Final Product/Process Change Notification

Document #:FPCN25336X

Title of Change:	Qualification Assembly site in UTAC Thailand for FSA2257L10X, FSUSB11L10X	
Proposed First Ship date:	28 Feb 2024 or earlier if approved by customer	
Contact Information:	Contact your local onsemi Sales Office or mitch.paris@onsemi.com	
PCN Samples Contact:	Contact your local onsemi Sales Office. Sample requests are to be submitted no later than 30 days from the date of first notification, Initial PCN or Final PCN, for this change. Samples delivery timing will be subject to request date, sample quantity and special customer packing/label requirements.	
Additional Reliability Data:	Contact your local onsemi Sales Office or Lalan.Ortega@onsemi.com	
Type of Notification:	This is a Final Product/Process Change Notification (FPCN) sent to customers. FPCNs are issued 90 days prior to implementation of the change. onsemi will consider this change accepted, unless an inquiry is made in writing within 30 days of delivery of this notice. To do so, contact PCN.Support@onsemi.com

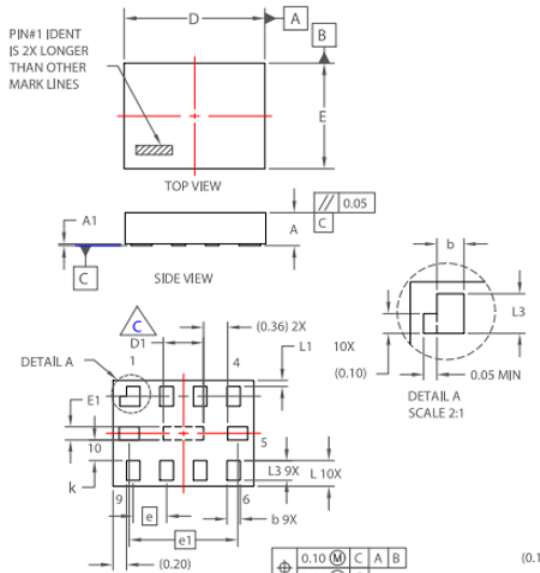
Dimension	HANA Thailand (existing)			UTAC Thailand (new site)			Remark
	Min	Nom	Max	Min	Nom	Max	
A	0.50	0.55	0.65	0.58	0.63	0.68	UTAC thicker than HANA

- Only dimension A was changed.

DESIGN NOTES:

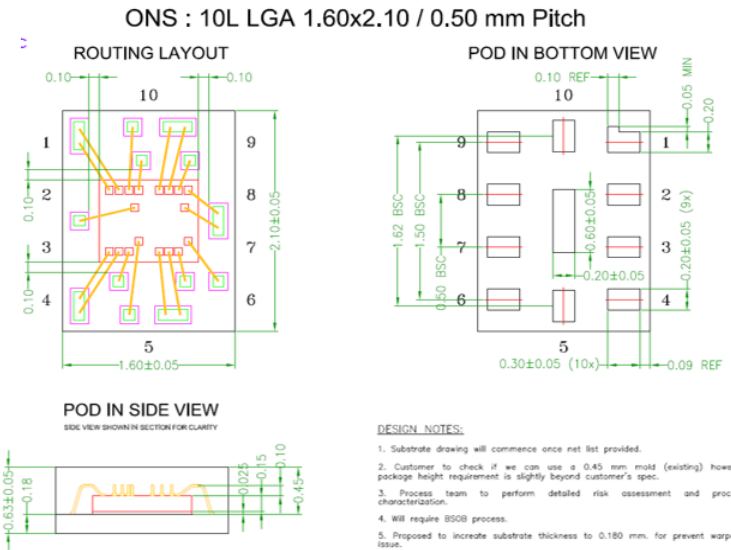
- Substrate drawing will commence once net list provided.
- Customer to check if we can use a 0.45 mm mold (existing) however package height requirement is slightly beyond customer's spec.
- Process team to perform detailed risk assessment and process characterization.
- Will require B50B process.
- Proposed to increase substrate thickness to 0.180 mm. for prevent warpage issue.
